Company	Trenz Electronic GmbH
PCN Number	PCN-20201003
Title	TE0890-01 SPI Flash Change
Subject	BOM change
Issue Date	2020-10-06

2.1 #1 Change SPI Flash from N25Q064A13ESE40F to IS25LP064D-JBLE

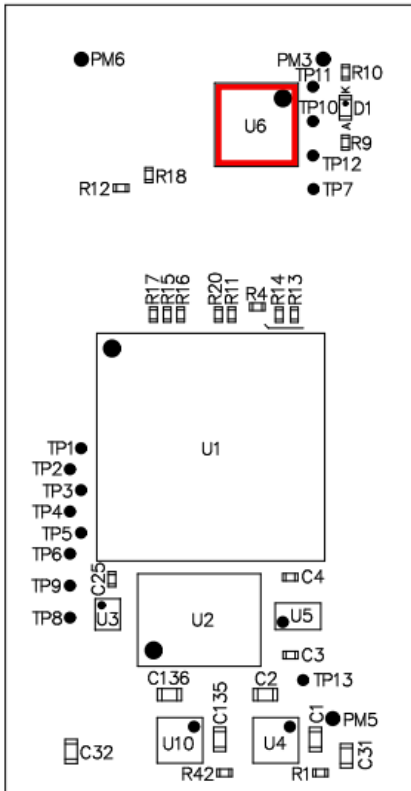
Type: BOM change

Reason: Old flash is obsolete.

Impact: JEDEC ID changes from BA17h to 6017h and manufacturer ID from 20h to 9Dh.

Locate Flash (U6) at top side of PCB:

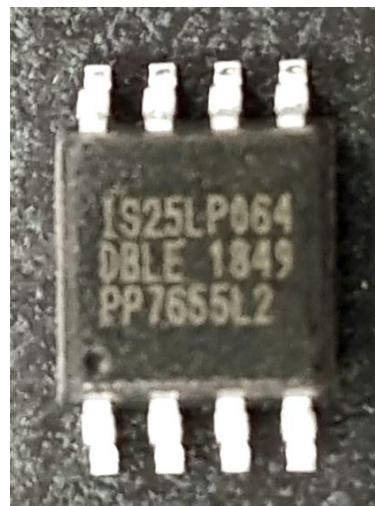
N25Q064A13ESE40F

IS25LP064D-JBLE
